## Technical Memorandum

Subject: Response to MEDEP Comments  
Phase 14 Solid Waste Permit Application - Volume 1  
Crossroads Landfill, Norridgewock, Maine

**ATTACHMENT RTC#22-1**  
**Itemized Tables of Phase 14 Closure and Post-Closure**  
**Projected Costs**

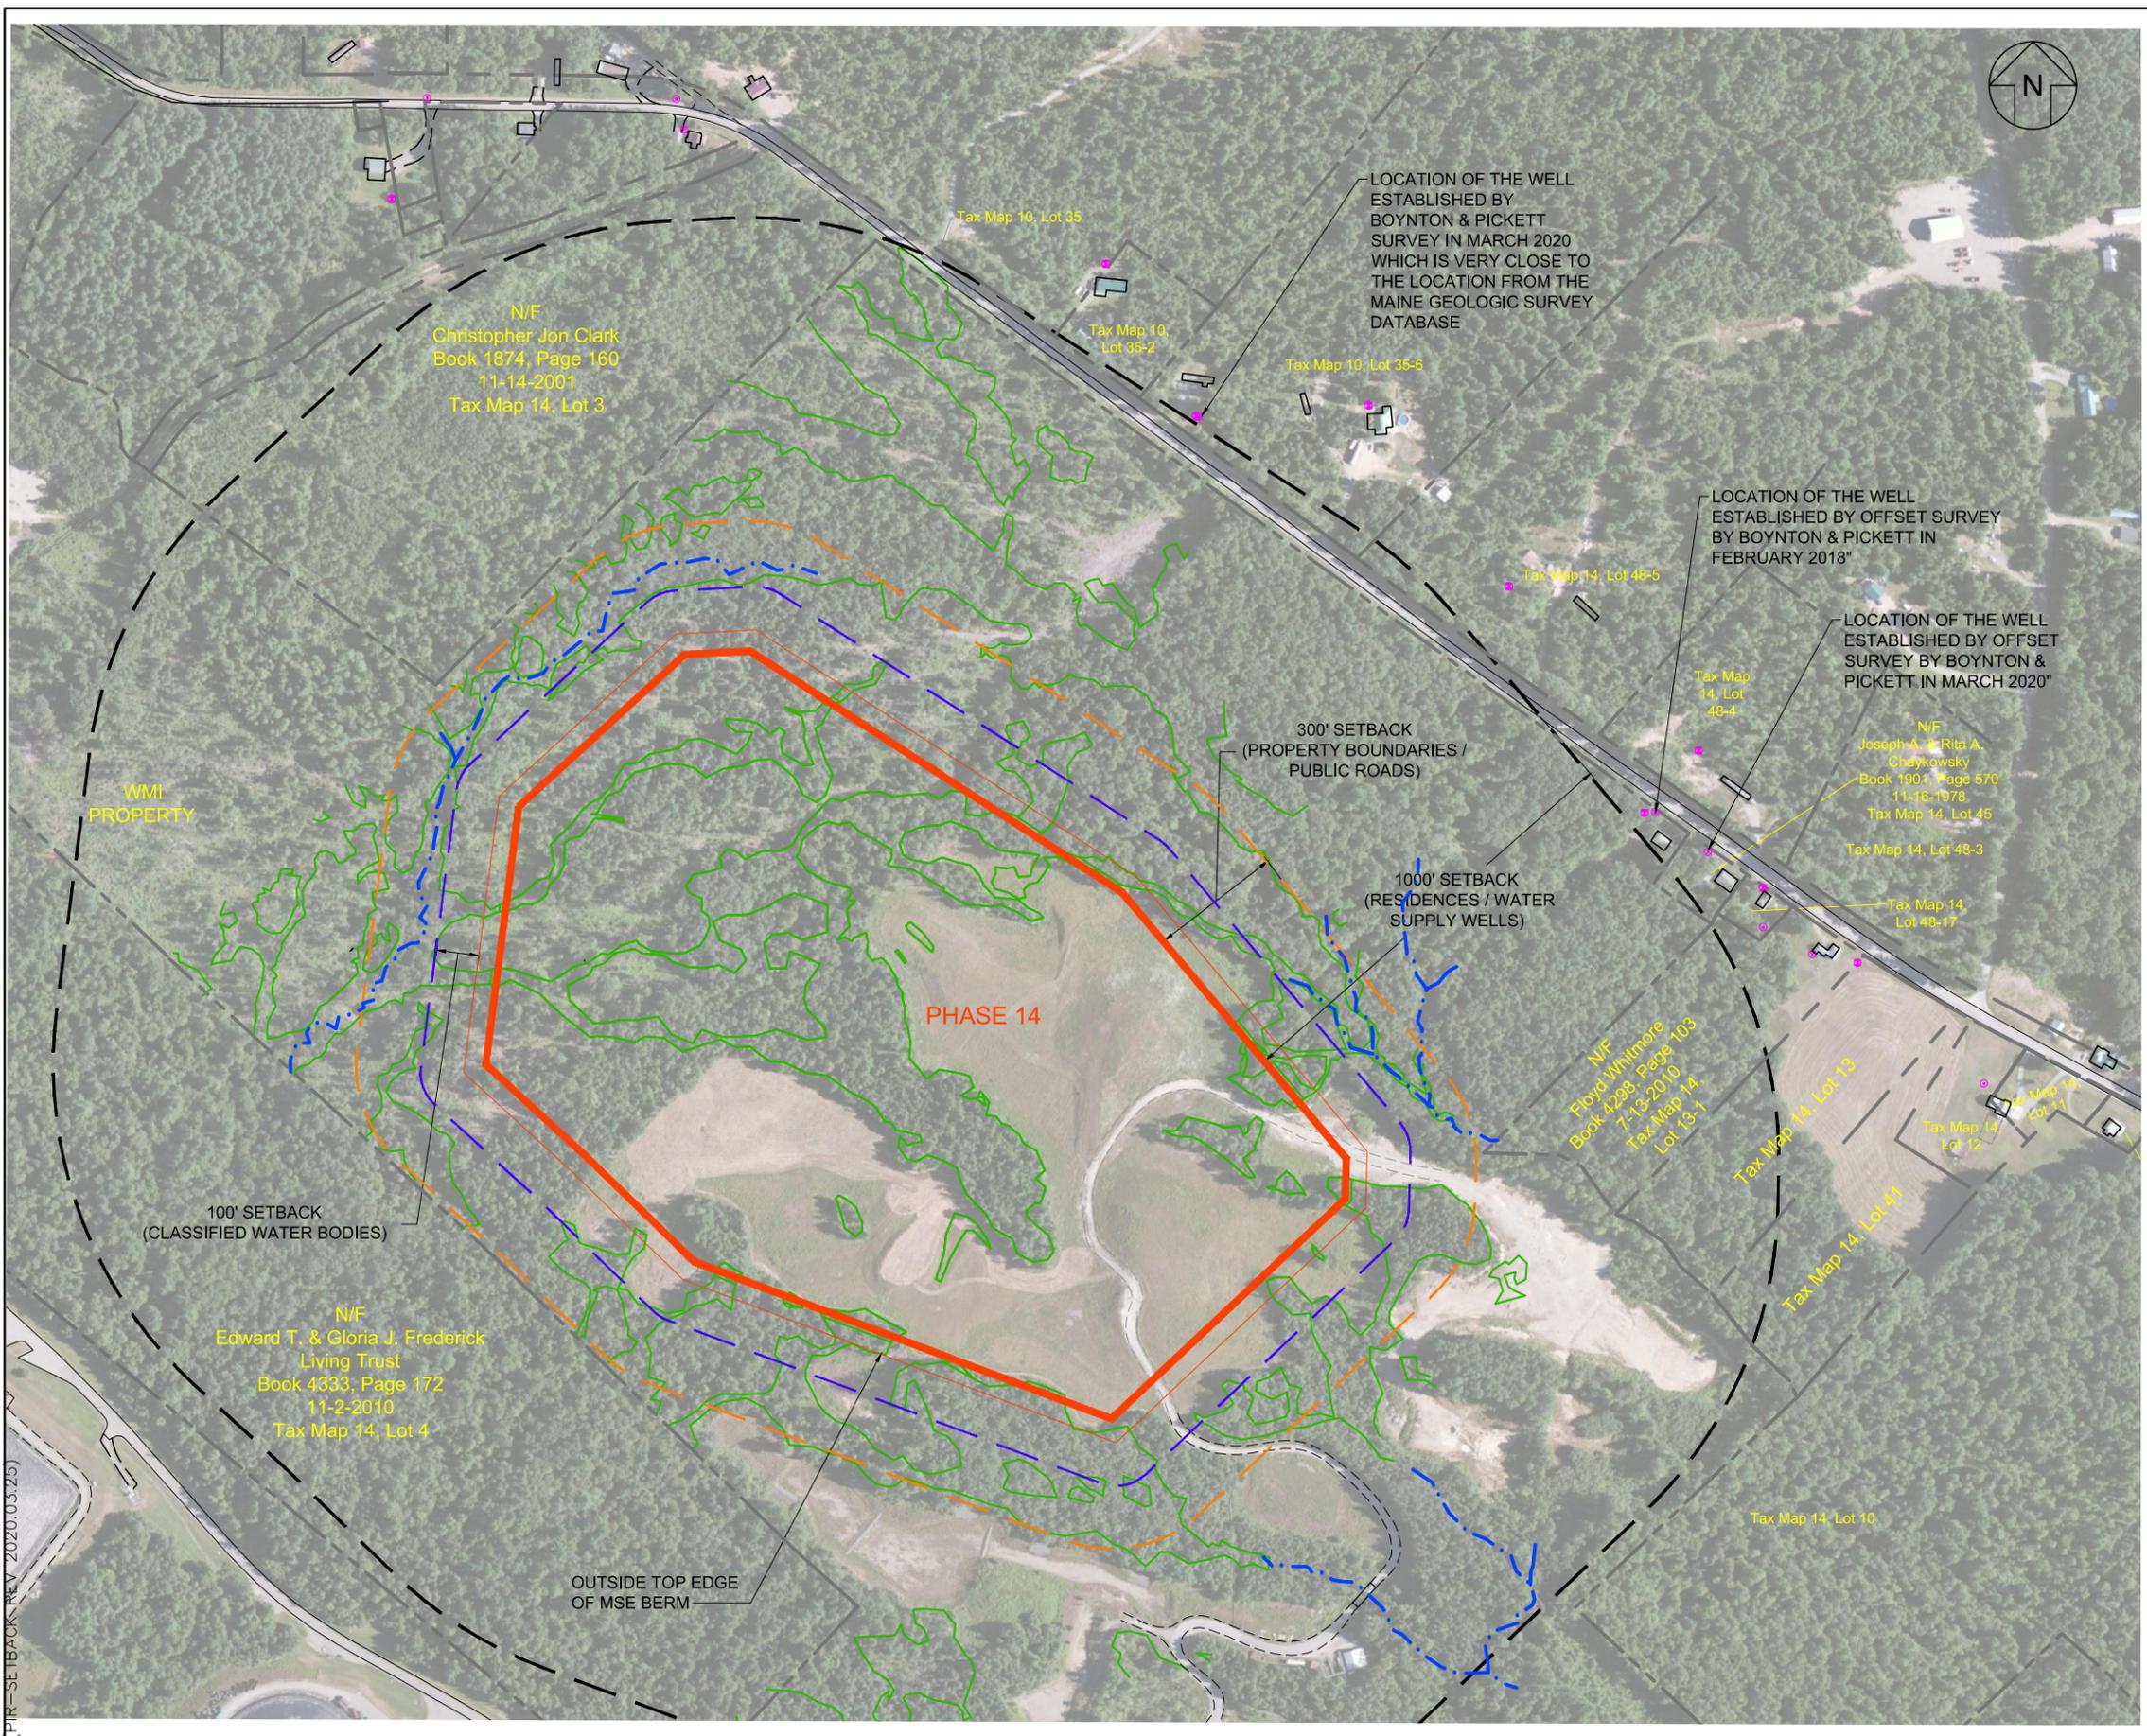
22. *Please provide a detailed breakdown to support the estimates provided on Schedule A of the amendment to the Trust Agreement dated April 21, 1993, as revised January 28, 2020 (submitted separately from the application).*

**Response to Comment 22.** Itemized tables of the projected closure and post-closure costs for Phase 14 are attached to this RTC technical memorandum as ATTACHMENT RTC#22-1. These projected costs were used to support estimates provided on Schedule A of the amendment to the Trust Agreement dated 21 April 1993.
